File In Section: Product Recalls
Bulletin No.: 10243B
Date: September 2010

PRODUCT SAFETY RECALL

SUBJECT: Second Row Safety Belt Interference When Seat Back Returned to Upright Position

MODELS: 2009-2010 Buick Enclave
2009-2010 Chevrolet Traverse
2009-2010 GMC Acadia
2009-2010 Saturn OUTLOOK

2523479

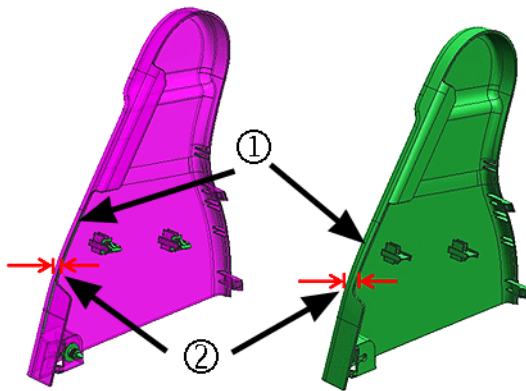
(3) Left hand 60 percent bench seat in its normal seating position. (4) Left hand 60 percent bench seat in the smart slide position. This is the position that the seat must be in to remove the recliner inner trim cover.

Note: The procedure below shows the rework being done on a left hand bucket seat trim cover. The same procedure should be done for the right hand bucket seat and both covers of the bench seat (60% and 40%). Refer to the illustrations above for examples of the different seat configurations.

2509078

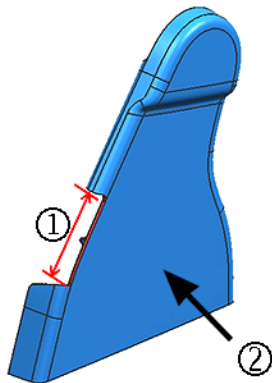
Note: The material to be removed is the standing ledge (1) in the notched-out opening, shown in the examples above. Depending on the design and seat configuration, approximately 12-15 mm (15/32-19/32 in) of material (2) will need to be removed so that the entire flange is removed all the way to the vertical wall of the cover.

5. Using a DREMEL®, cut-off wheel, or similar tool, grind off/remove the cover's standing ledge material in the notched-out opening.
